Wastewater Treatment Plant Review

Crosslake, Minnesota

B11.111502

City of Crosslake, Minnesota
BMI Project Number B11.111502

Figure 2 - Crosslake WWTP PHWW Capacity

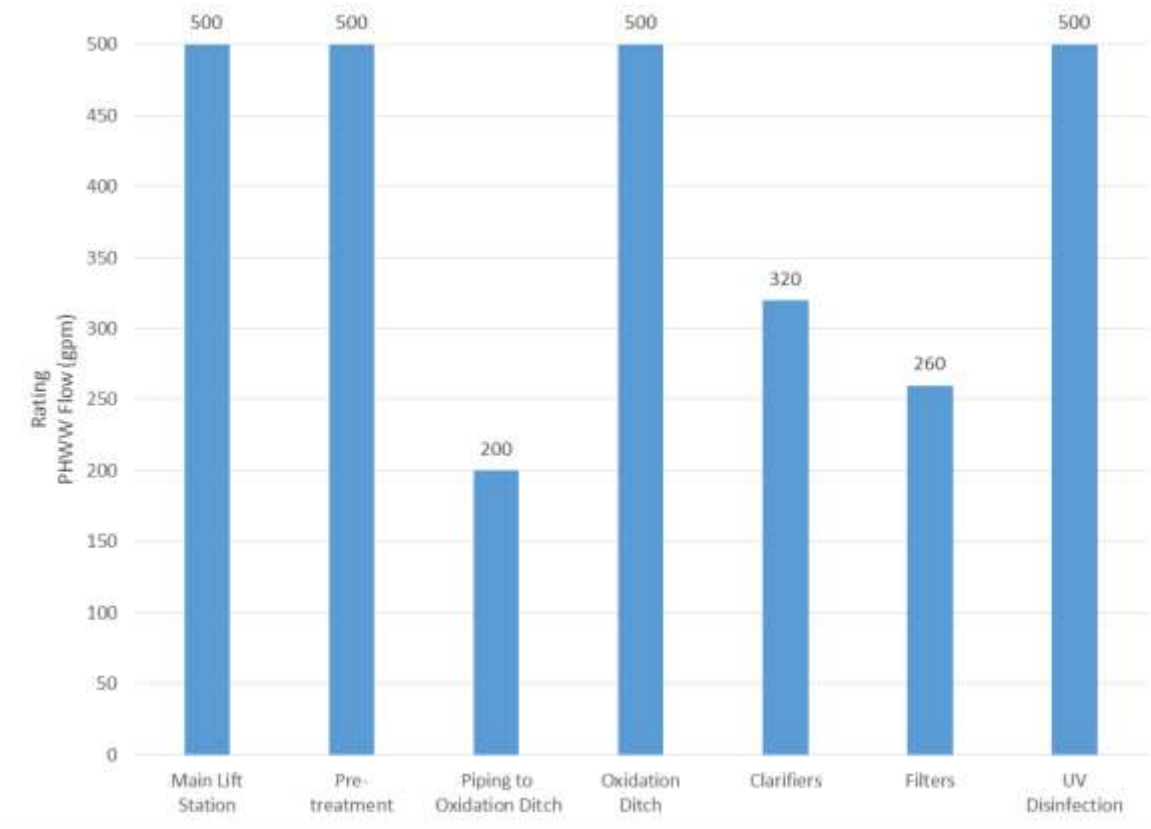
A summary of each treatment process or pipeline is presented in Figure 2 below. As can be seen the facility has significant deficiencies at the oxidation ditch feed piping, secondary clarifiers and tertiary filters on a PHWW flow basis.
